# Service Information

Category <b>U</b>	<b>Repair Guidance</b>	Ref. No. R103/16A <b>REV</b>	Page 1 of 4
Coverage <input type="checkbox"/> Distributor only <input checked="" type="checkbox"/> Please inform your dealers		Date Issued November 25, 2016	
Please convey this information to your <input type="checkbox"/> Director <input checked="" type="checkbox"/> General Manager <input checked="" type="checkbox"/> Warranty Dept. <input checked="" type="checkbox"/> Parts Dept. <input checked="" type="checkbox"/> Training Dept. <input checked="" type="checkbox"/> Field Rep.		Date Revised <b>June 14th, 2017</b>	
Applicable Model  Mazda2(DJ), CX-3 (DK)		Applicable Countries or Specifications  Worldwide

## Subject: Air Conditioner - No Cool Air (Condenser Leakage)

TRACE of A/C  
REFRIGERANT LEAK

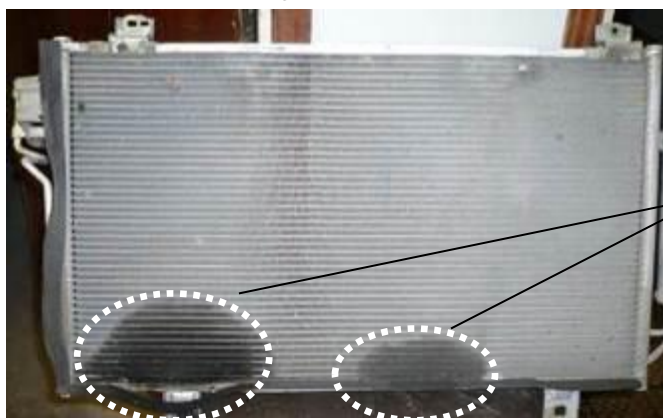
1. Visually inspect the condenser for A/C refrigerant leak
  - If a trace of A/C refrigerant leak as shown in the figure has been found, go to next step.

- If no leak has been found, this Service Information is not applicable. Diagnose for other concerns according to the Workshop Manual.
2. Replace the condenser with a modified one according to the workshop manual "CONDENSER REMOVAL/INSTALLATION".
3. Verify repair.
